**RE: Effluent Field, Mehrtens Residence, U021236**

## **Application for Resource Consent-Mehrtens, Kelvin**

**Application for Resource Consent**  
**Mehrtens, Kelvin**  
**Worlds End Road Penzance Bay Central Pelorus West**  
**Section 92 – Request for Further Information**

**RE: Effluent Field, Mehrstens Residence, Lot 15 Worlds End Road, Penzance Bay**

**EFFLUENT FIELD  
LAYOUT**

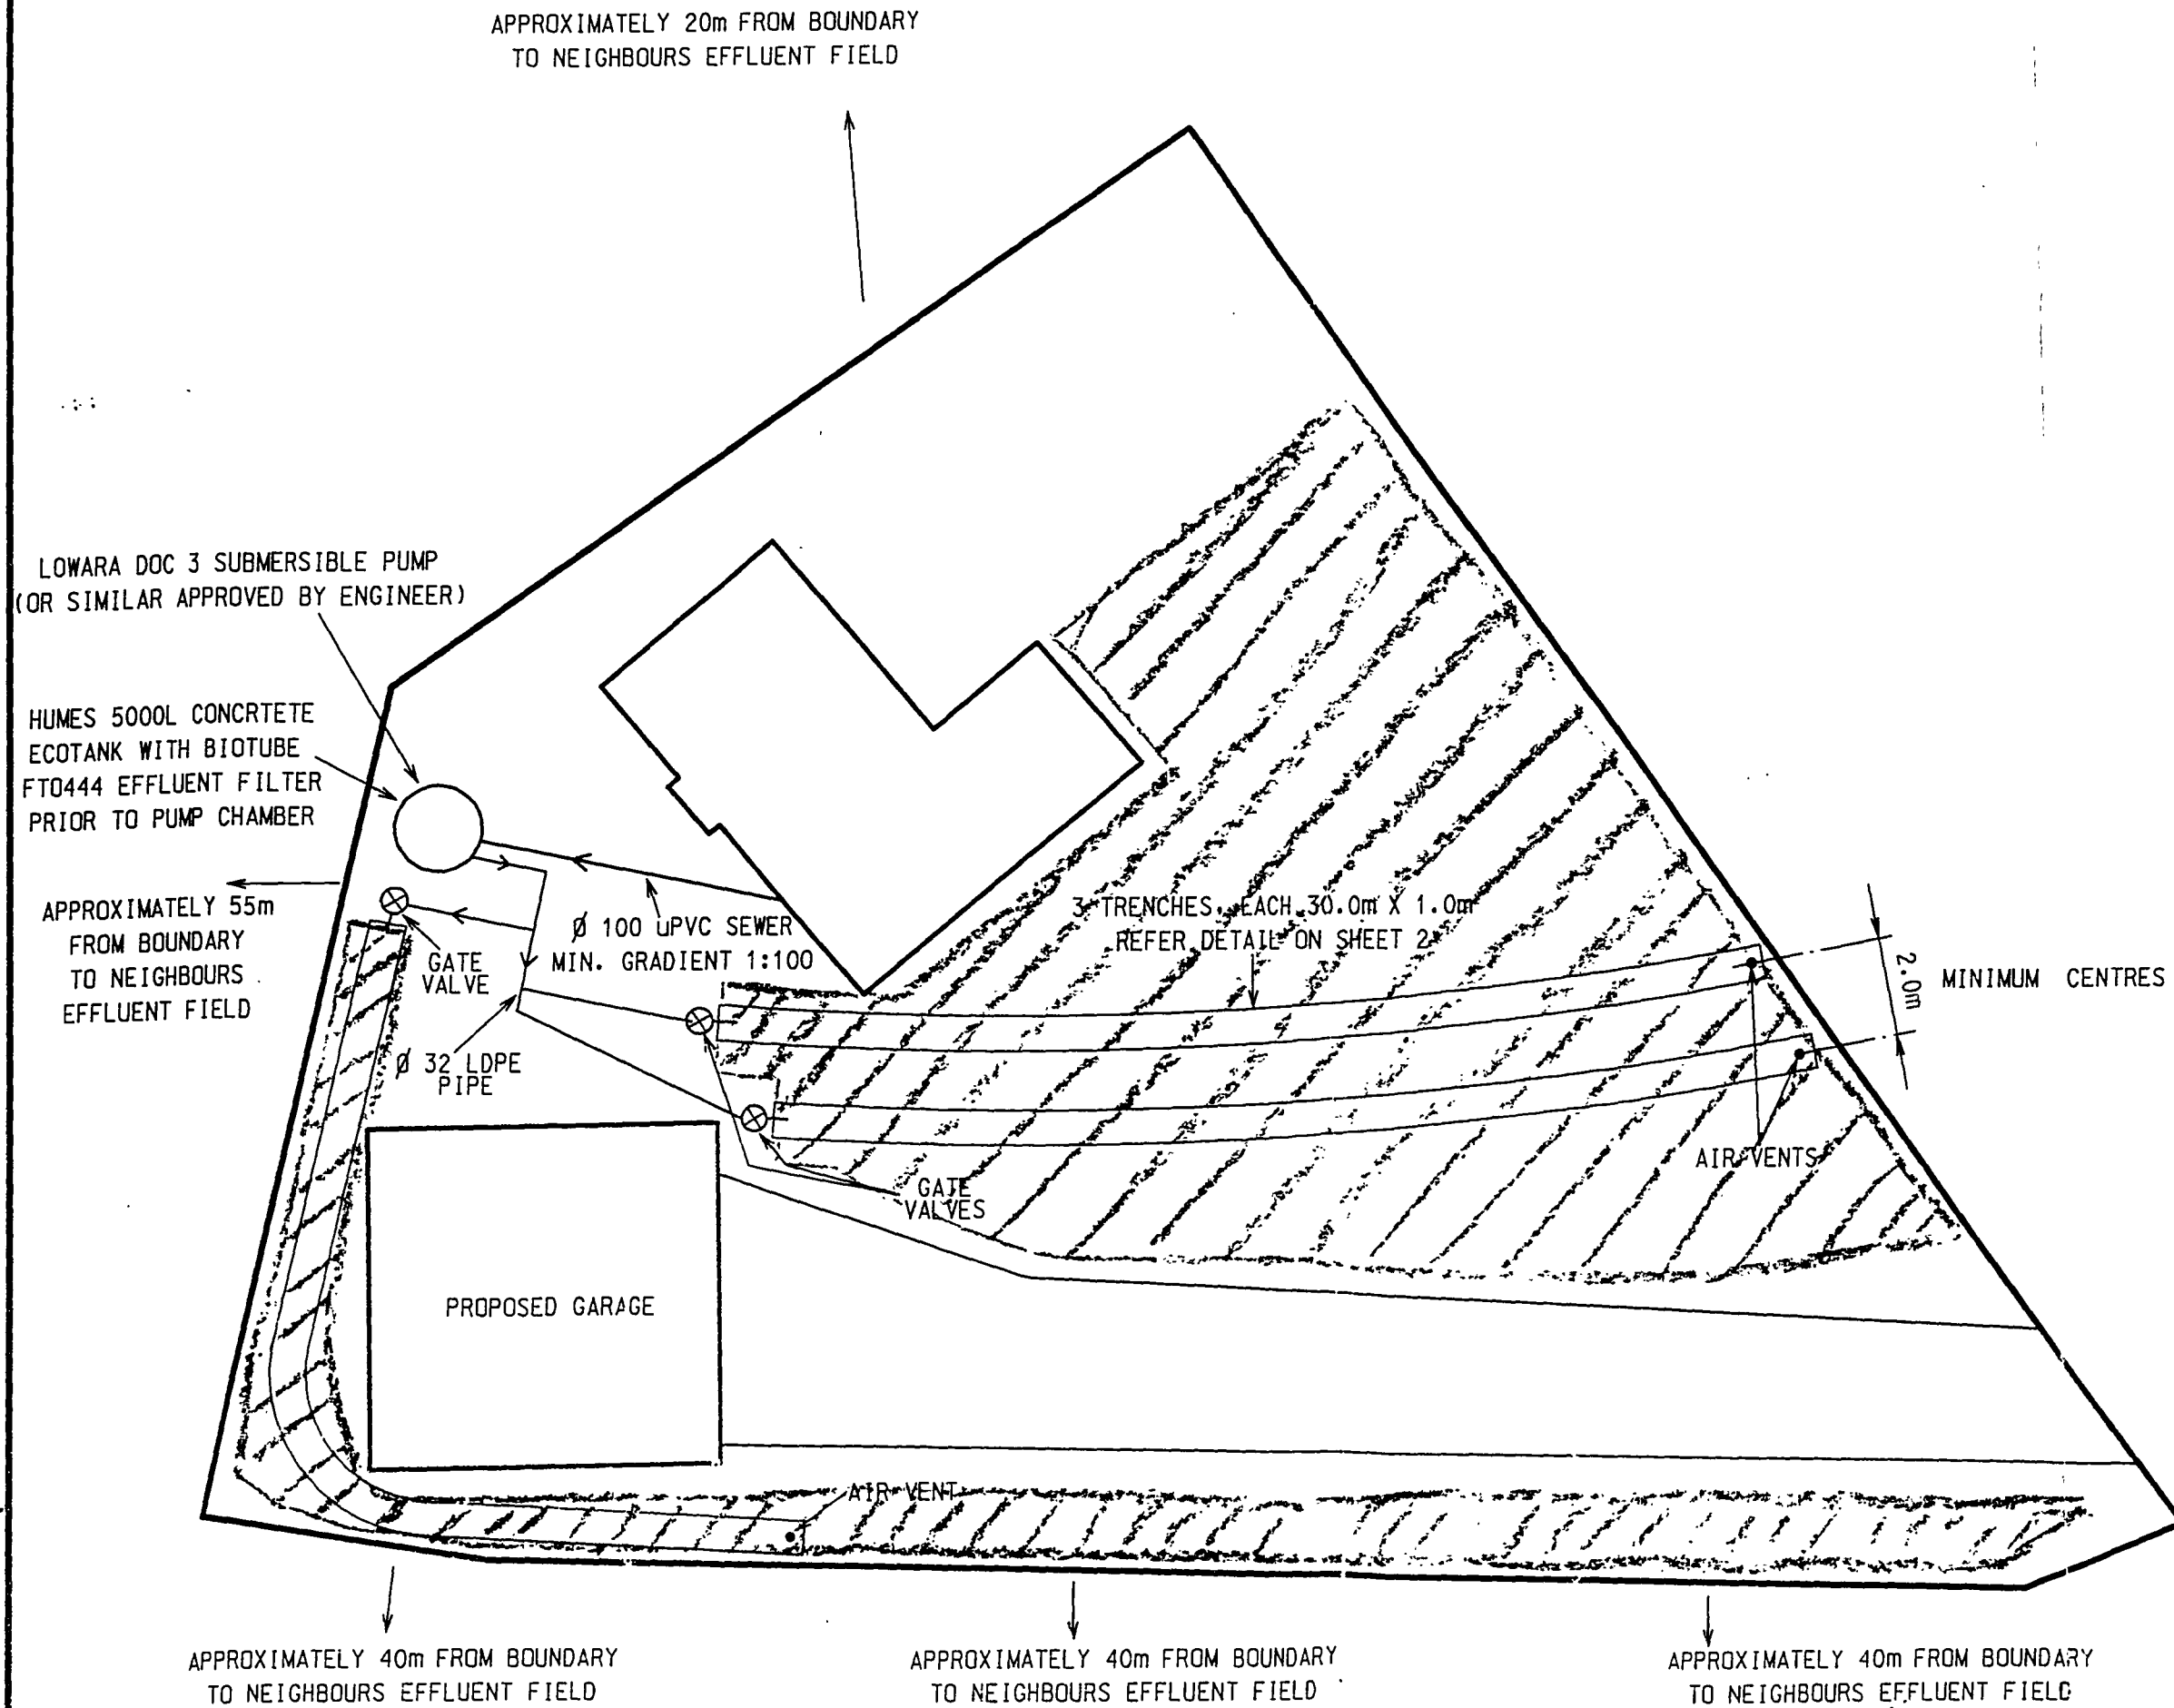
I'm sure you are aware that these conditions must be complied with regardless of any conditions imposed under a discharge permit, therefore could you provide a scale diagram showing the 400m<sup>2</sup> of suitable disposal area (to allow for adequate reserve).

Please find attached our drawing 12050 amendment C, showing approximately 600 m<sup>2</sup> suitable for effluent treatment.

AREA SUITABLE FOR EFFLUENT TREATMENT 600m<sup>2</sup> SHOWN.

Drawing Title  
**EFFLUENT FIELD  
LAYOUT**

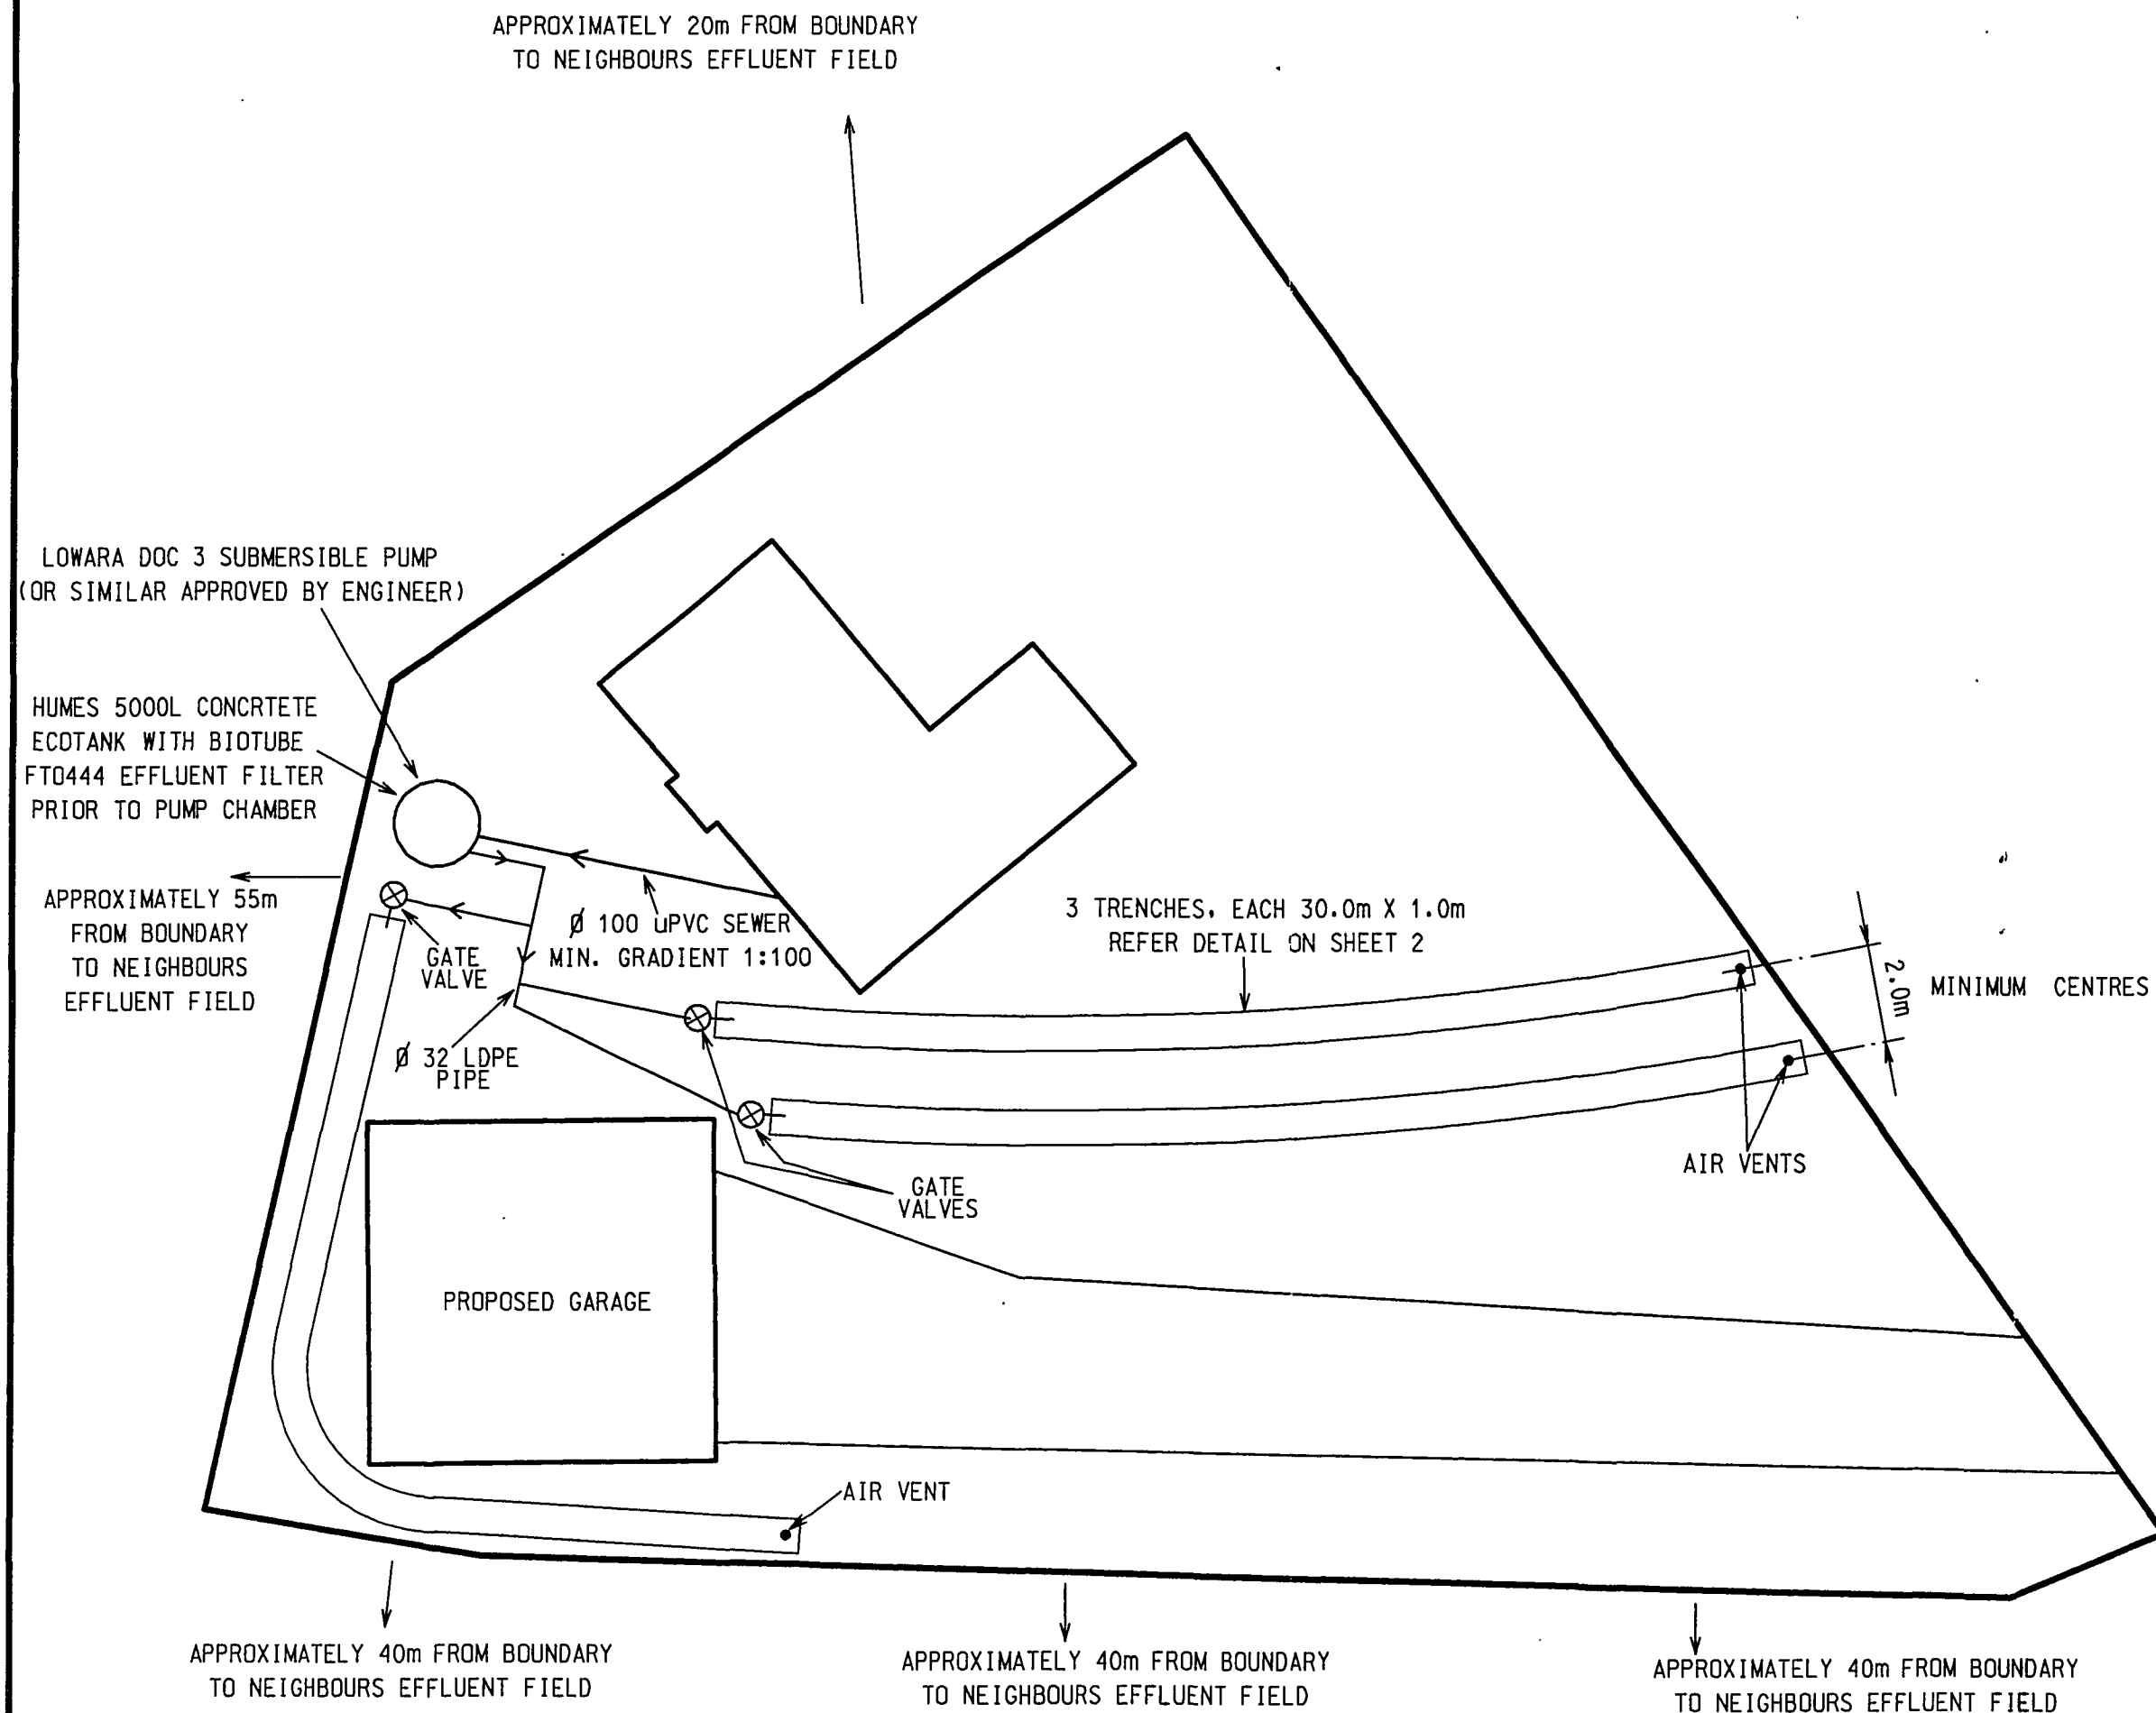
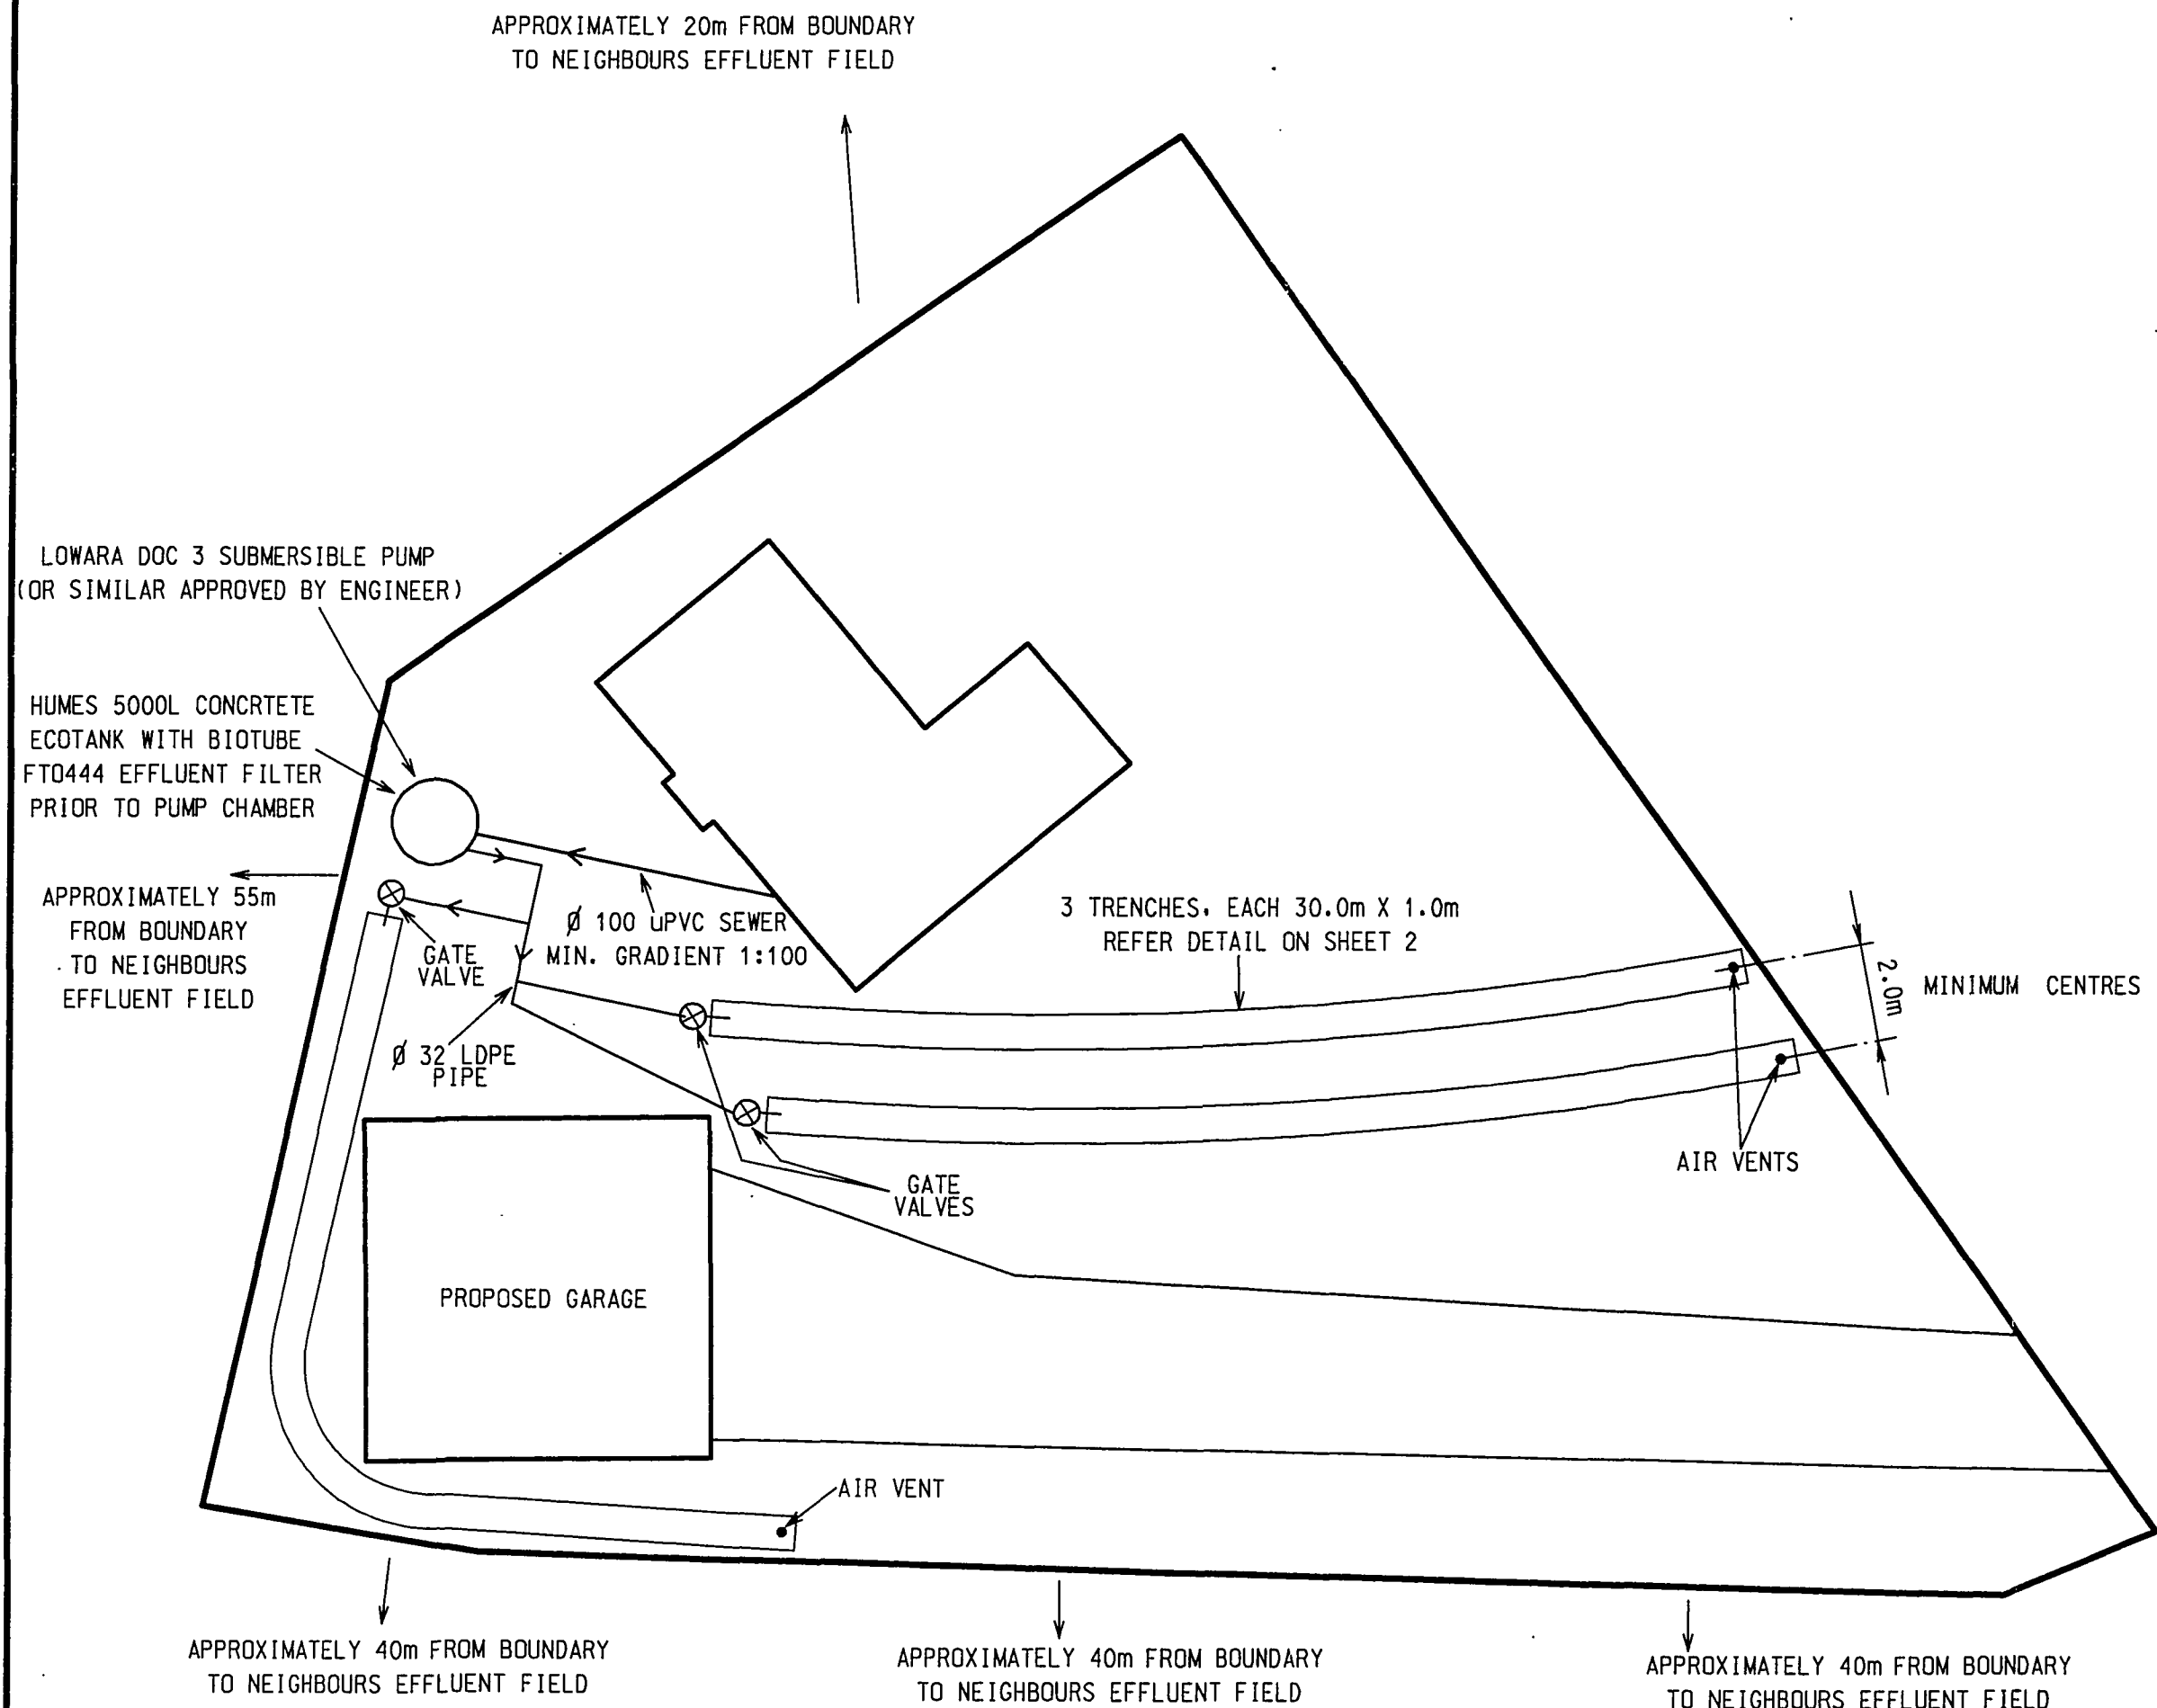
You make a statement that the topography in the area of the proposed northern trench would make installation problematic, and is unlikely to operate satisfactory. We require more detail from you as to what the problem actually is, before we can respond.

I note that the trench width in the application is 800 mm. AS/NZS 1547:2000 (table 4.5A1) gives a maximum trench width of 600mm.

Also after recently visiting the site it appears that the topography in the area of the proposed northern trench would make installation problematic and the trench is unlikely to operate satisfactorily.

We are unhappy that the statutory time clock has stopped, and therefore we have changed our design as per the attached drawings. We trust these changes adequately address your concerns.
